SEWAGE DISPOSAL SYSTEM

HOWARD COUNTY HEALTH DEPARTMENT

P 57002A

SUBDIVISION _____ LOT _____ ROAD 1443 Woodstock Road

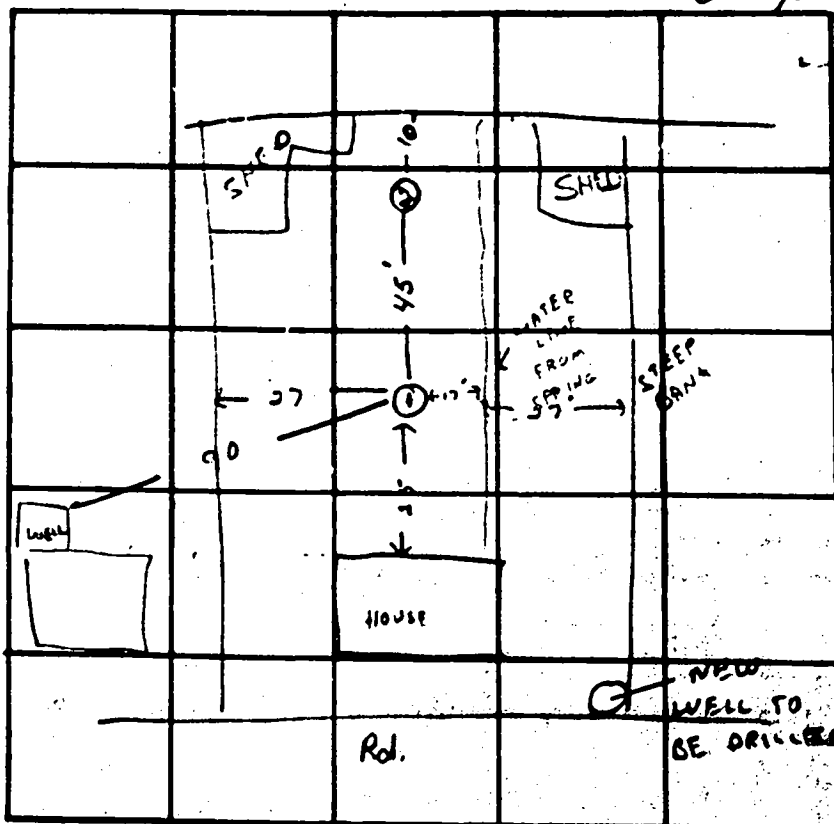
REMARKS
 ① PIPE NEEDED FROM HOUSE TO SEPTIC TANK
 ② LEVEL GRAVEL AROUND DRY WELL.
 ③ CALL FOR APPOINTMENT WHEN READY
 ④ OK TO COVER DRY WELL + SEPTIC TANK EXCEPT
 WHERE PIPE COMES IN FROM HOUSE TO SEPTIC TANK 9-22-75
 1-17-75 OK to cover 1/2

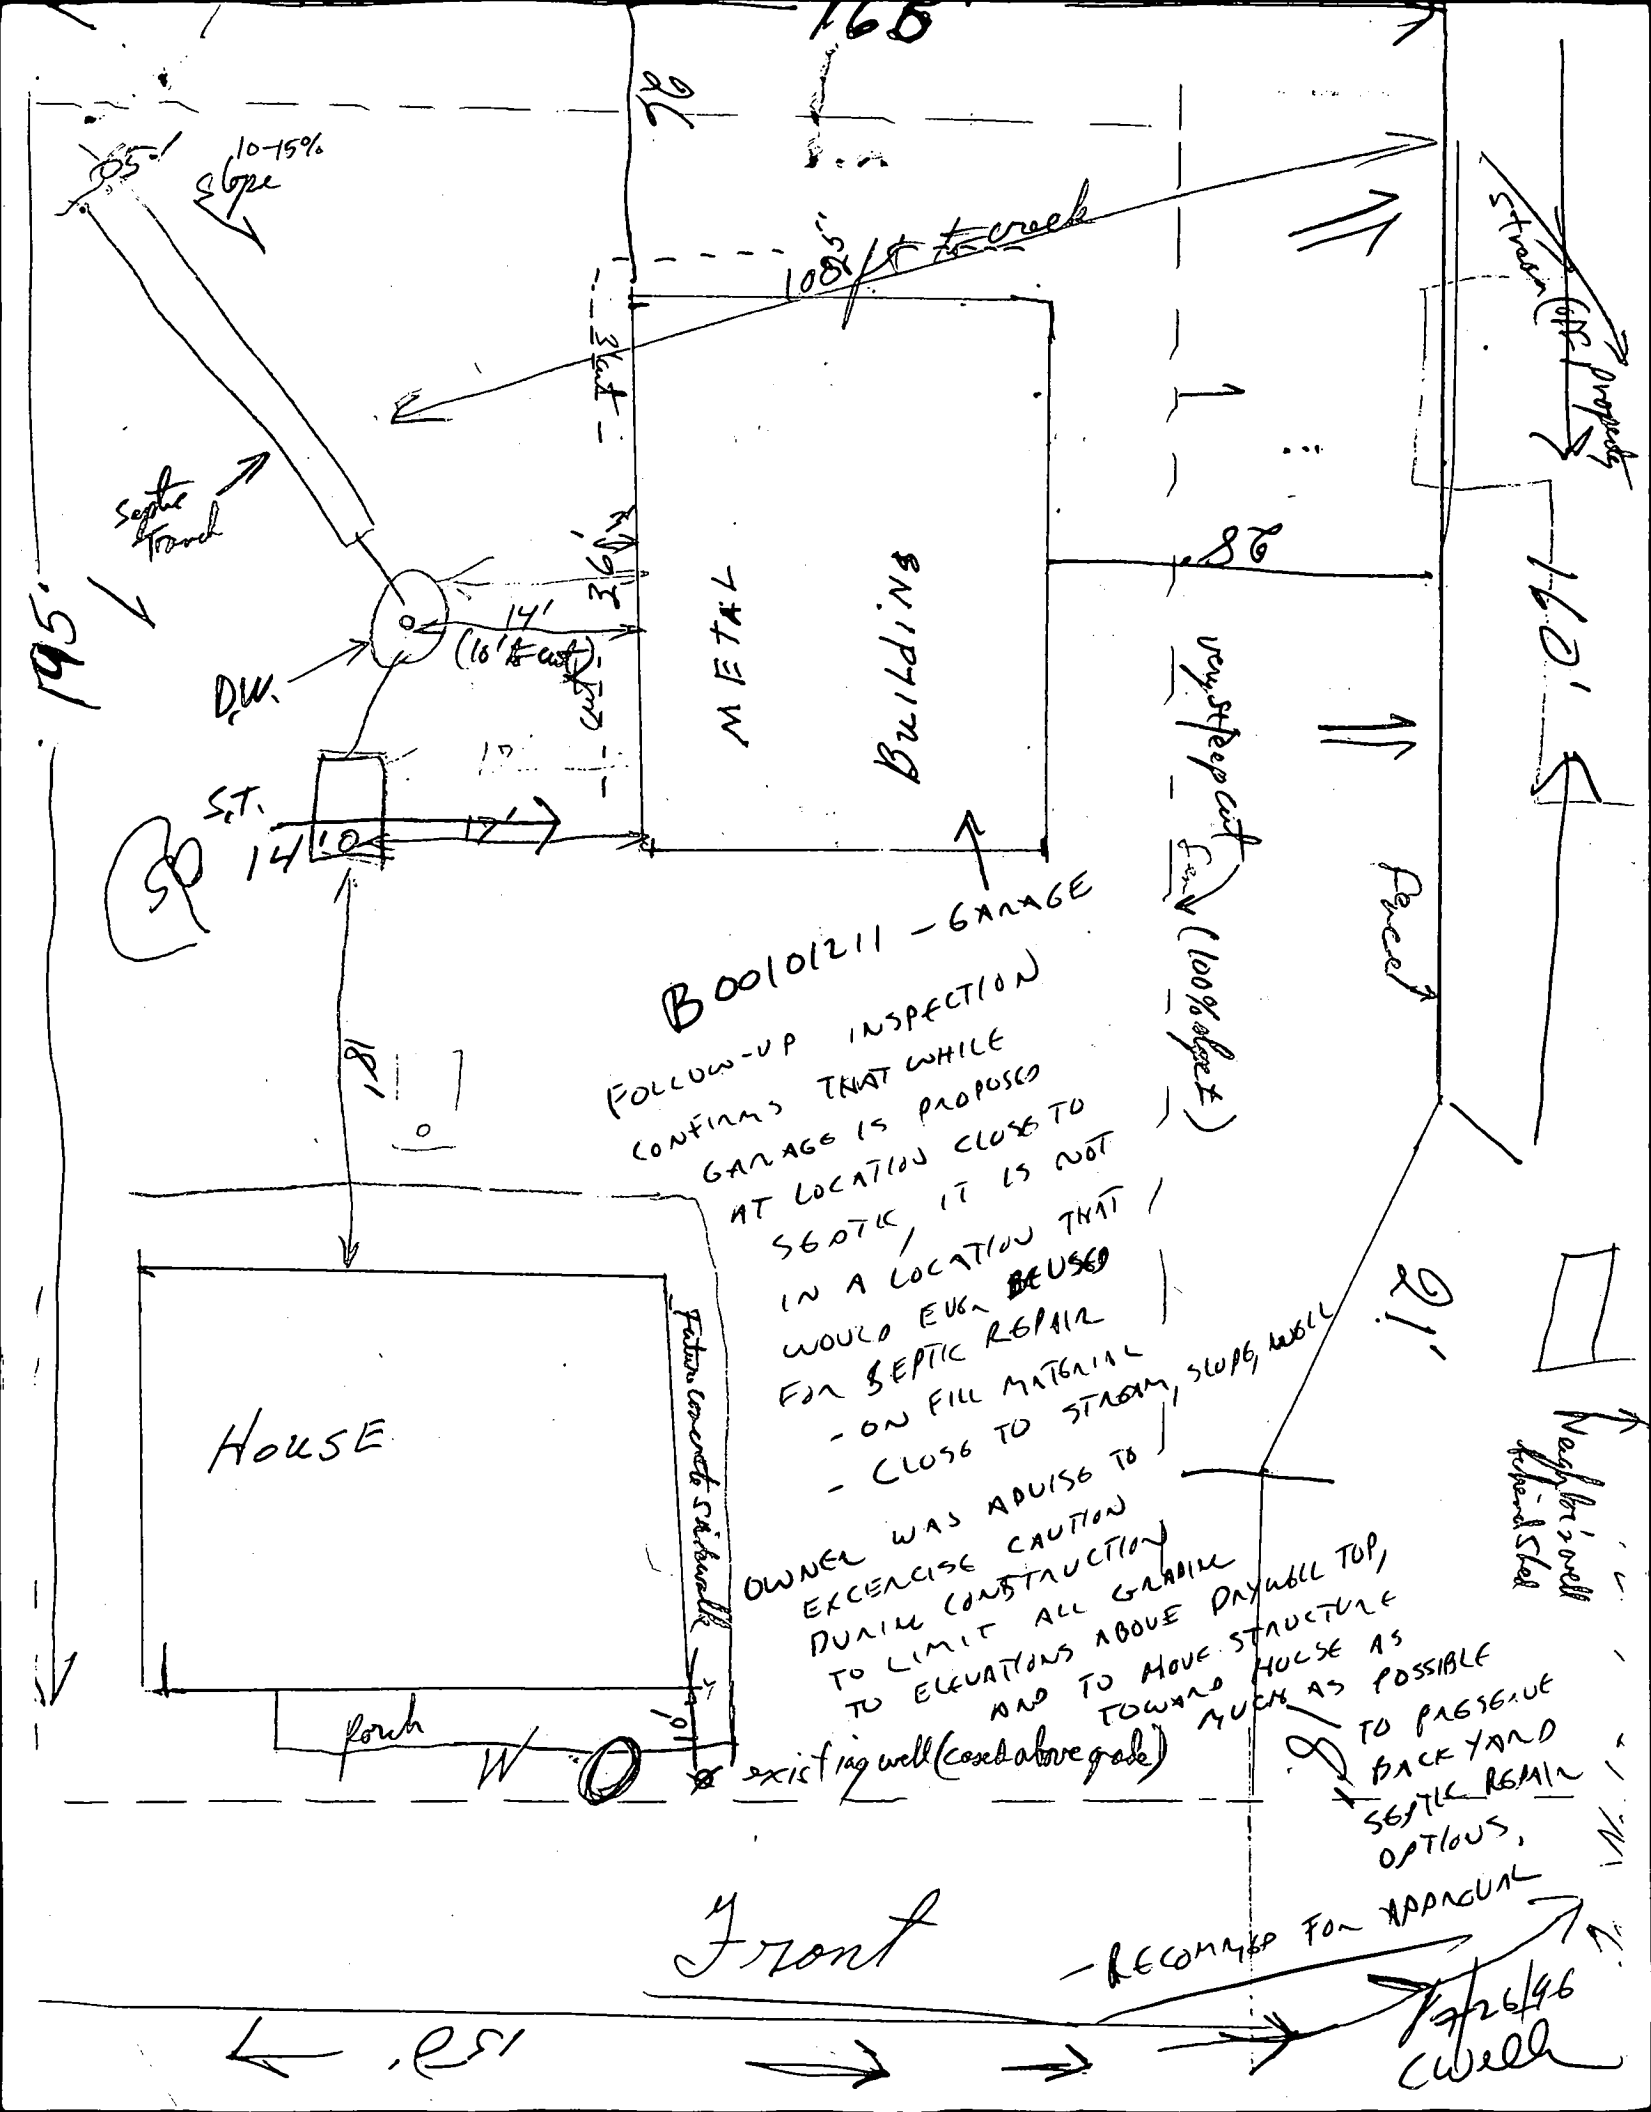
Site for garage is already cut, all backyard has been recently graded.
Unable to see anything significant, but I can smell an odor like wastewater
(recent rains has eroded some soils & created some mud puddles - so if any

septic seepage occurred it is covered now. Owner (Martha Clements)
said Neighbor's garage runs rain water runoff across her property but that
was recently redirected by Bldg inspector.

Problem is existing dry well is too close to garage site -
(clearcut Ext. in center of D.W. is only 14' from proposed Bldg line and 10' from
begin of 3' deep cut). However Garage Site is Not usable for Future Septic repair because of nearby steps (gpc)

I recommend No approval at this time.

I suggest calling owner in to discuss options,
i.e. ① how he plans to construct garage & cut to prevent
a sewage Read out, ② possible abandonment & filling
of existing drywell, going on to direct S.T. - Drain
line connection. Please discuss. RPP/mhly
